# Work Order ID 77533

Item Name: Crosstube Aft

DRAWING NO. D412-664-243	TITLE CROSSTUBE ASSEMBLY (412 HI AFT)	REV. E	DART AEROSPACE LTD ENGINEERING ORDER		D.E.O. NO. D412-664-243-E-1	SHEET NO. SHEET 1 OF 2	SCALE NTS
DRAWN	CHECKED <i>MP</i>	MFG. APPR. <i>E</i>	APPROVED <i>MP</i>		DE APPR. <i>MP</i>		
DATE 11.03.31	DATE 11/03.31	DATE 11.03.31	DATE 11/03.31		DATE 11.03.31

DRAWING NO. D412-664-243	TITLE CROSSTUBE ASS'Y (412 HI AFT)	REV. E	DART AEROSPACE LTD ENGINEERING ORDER		D.E.O. NO. D412-664-243-E-2	SHEET NO. SHEET 1 OF 1	SCALE NTS
DRAWN JP	CHECKED ASS	MFG. APPR. E	APPROVED MP		DE APPR. H		
DATE 11.09.07	DATE 11.09.19	DATE 11.09.19	DATE 11.09.19		DATE 11.09.19

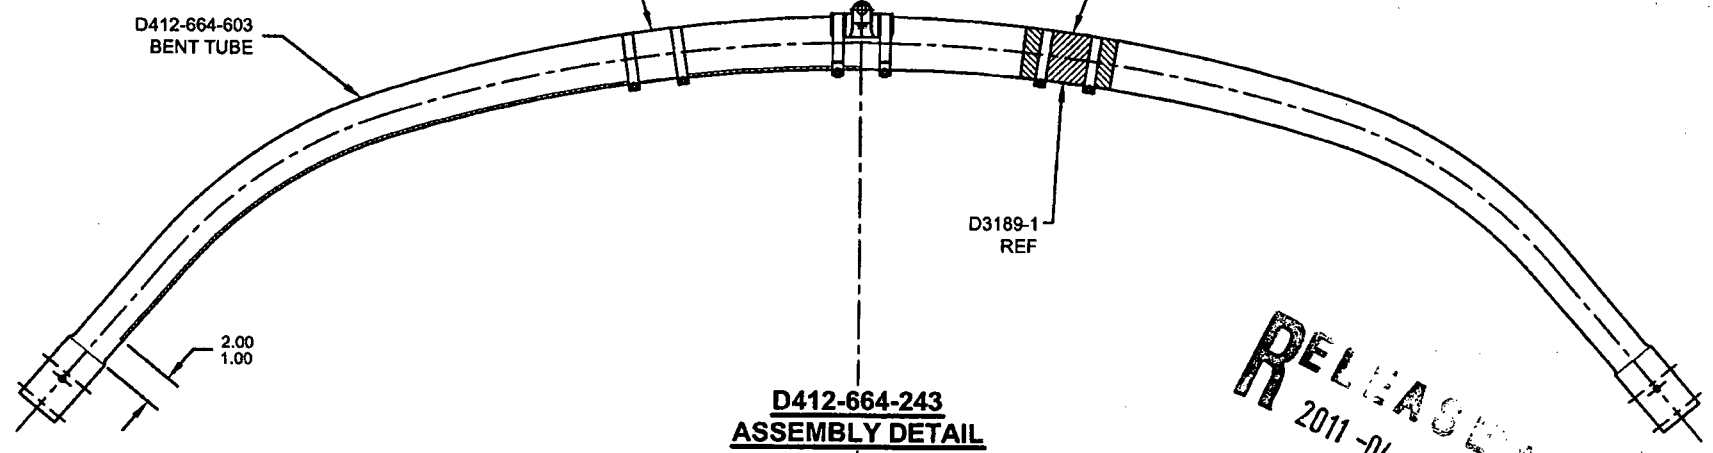
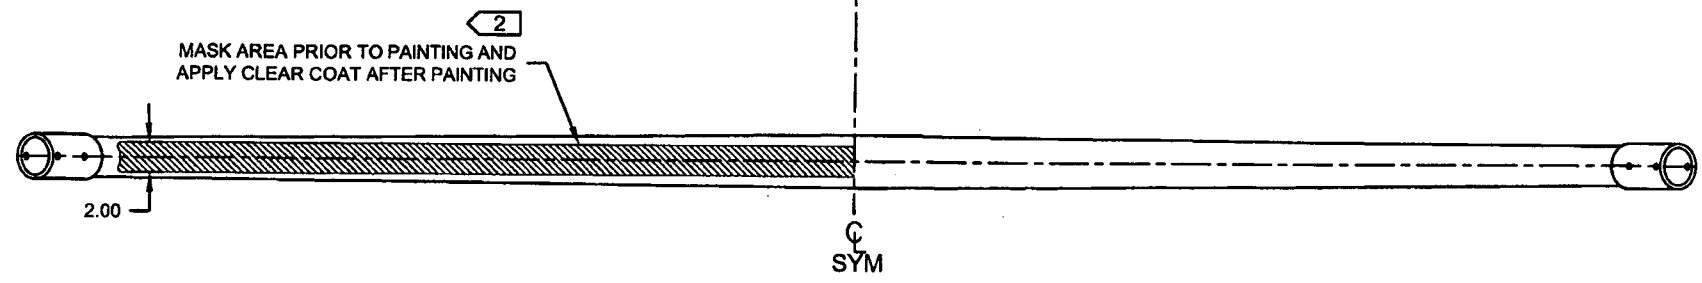
**PURPOSE:**

REMOVED ABRASION STRIP IN FAVOR OF A THIN LAYER OF PROSEAL 890.

**IS:**

D3189-1 CHAFING SHIELD (1, INSTALLED OVER PROSEAL 890)  
MS21920-28 CLAMP, 2X  
2 PL

**WAS:**

D2856-600-1009 ABRASION STRIP  
D3189-1 CHAFING SHIELD (1, INSTALLED OVER ABRASION STRIP)  
MS21920-28 CLAMP, 2X  
2 PL

CRUSHING OF D412-664-243

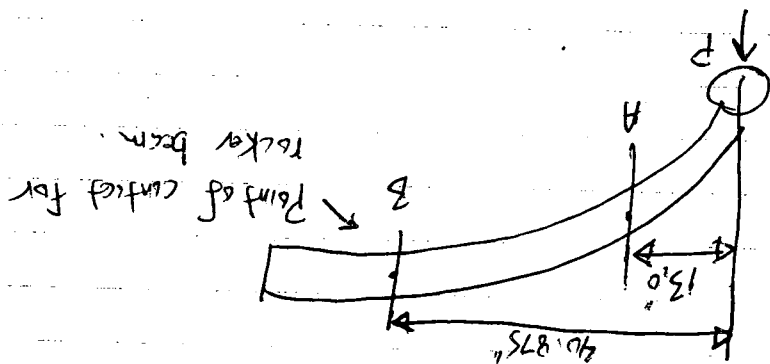
Acceptability of 8% CRUSHING AT END OF BEND

Point A:  $CD_1 = 2.961$ ,  $CD_2 = 2.522$

CRUSHING =  $(2.961 - 2.522) / (2.961 + 2.522) = 8\%$   
 $I = 1.676 \text{ in}^4$  (from AutoCAD)  
 Point B:  $CD_1 = 3.307$ ,  $I = 4.613 \text{ in}^4$

A:  $F = M_c / I = P \times 13 \times 2.961 / 2 \times 1.676 = 11484.8 \cdot P$   
 B:  $= P \times 40.875 \times 3.307 / 2 \times 4.613 = 14.651 \cdot P$

M.S. =  $14.651 / 11.484 - 1 = 0.27$

∴ Tube will break at rocker beam contact before area of 8% crushing, 8% crushing in area at end of tube  
 bend is acceptable
